MRP appreciates the opportunity to provide these comments on the CAISO's March 19, 2021 Market Enhancements for Summer 2021 Readiness Final Proposal and the associated draft tariff language.

MRP Comments on Final CAISO Wheeling/Export Proposal and Tariff Language
April 2, 2021

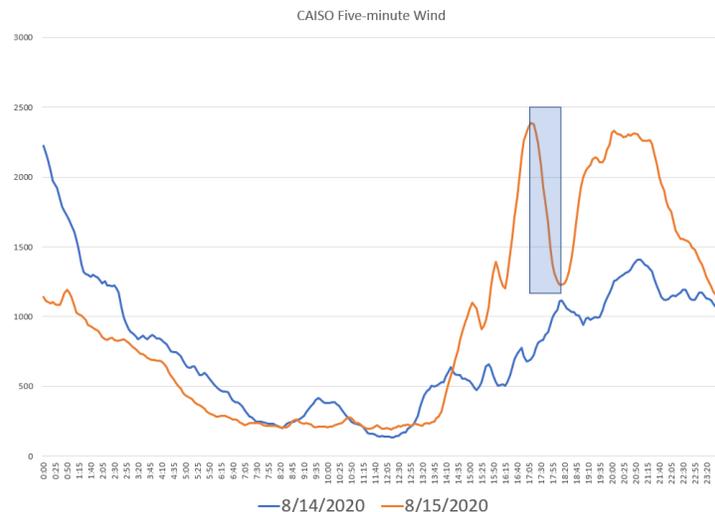
MRP: The CAISO is proposing that a VER can serve as a supporting resource if its forecasted production is at least as great as the export it is supporting. MRP notes that, on August 15, 2020, the CAISO experienced a sharp reduction in wind production. Was this decrease forecast? Under the CAISO's proposed rules, could wind resources have served as supporting resources during the decrease in production (the shaded area in the graph below) based on their forecast levels prior to the sharp decline on August 15?
